Item Name: Crosstube Turning Detail

Draw Nbr	Revision Nbr
D407-667-145	Rev C

DRAWING NO. D407-667-145	TITLE CROSSTUBE ASS'Y (407 HIGH FWD)	REV. C	DART AEROSPACE LTD ENGINEERING ORDER		D.E.O. NO. D407-667-145-C-1	SHEET NO. SHEET 1 OF 1	SCALE NTS
DRAWN 47	CHECKED ASS	MFG. APPR. BS	APPROVED WD		DE APPR. H		
DATE 11.07.15	DATE 11.07.22	DATE 11.07.22	DATE 11/07/22		DATE 11.07.21

DRAWING NO. D407-667-145	TITLE CROSSTUBE ASS'Y (407 HIGH FWD)	REV. C	DART AEROSPACE LTD ENGINEERING ORDER	D.E.O. NO. D407-667-145-C-2	SHEET NO. SHEET 1 OF 1	SCALE NTS
DRAWN AJS	CHECKED J	MFG. APPR. E	APPROVED 140	DE APPR. H		
DATE 12.08.02	DATE 12.08.02	DATE 12.08.02	DATE 12.08.02	DATE 12.08.02	DATE 12.08.02

DETAIL P
BONDING STRAP INSTALLATION 2 PL

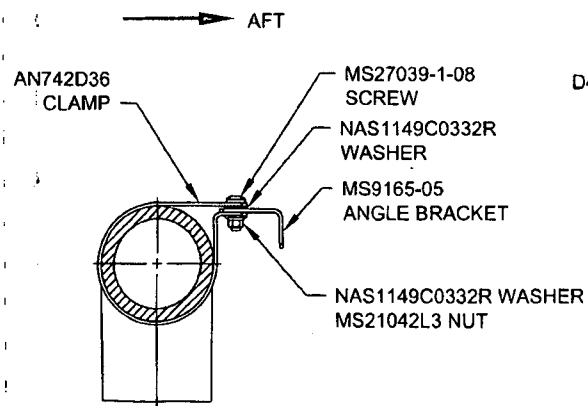
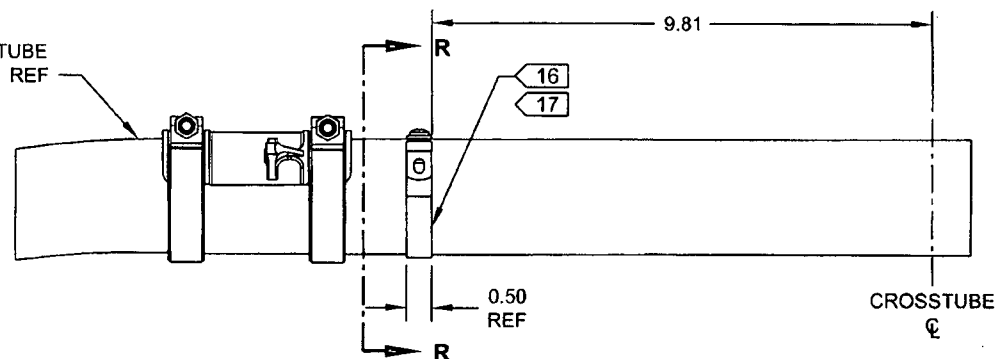
ADD ELECTRICAL GROUNDING STRAP

ITEM	QTY -145	PART NUMBER	DESCRIPTION
1	X	D407-667-145	CROSSTUBE ASSEMBLY (407 HIGH FWD)
10	2	AN742D36	CLAMP
11	2	MS9165-05	ANGLE BRACKET
12	2	MS21042L3	NUT (OR MS21042-3)
13	2	MS27039-1-08	SCREW
14	4	NAS1149C0332R	WASHER (OR AN960C10L)

- 16) MASK AREA UNDER CLAMP PRIOR TO PAINTING
- 17) SEAL EDGES WHERE AN742D36 CLAMP MEETS WITH THE CROSSTUBE USING SIKAFLEX-241/-291 OR MIL-S-8802 CLASS B2 OR PROSEAL 890 SEALANT
- 18) PERFORM RESISTANCE CHECK TO ENSURE MAX RESISTANCE IS 10 MEGOHMS
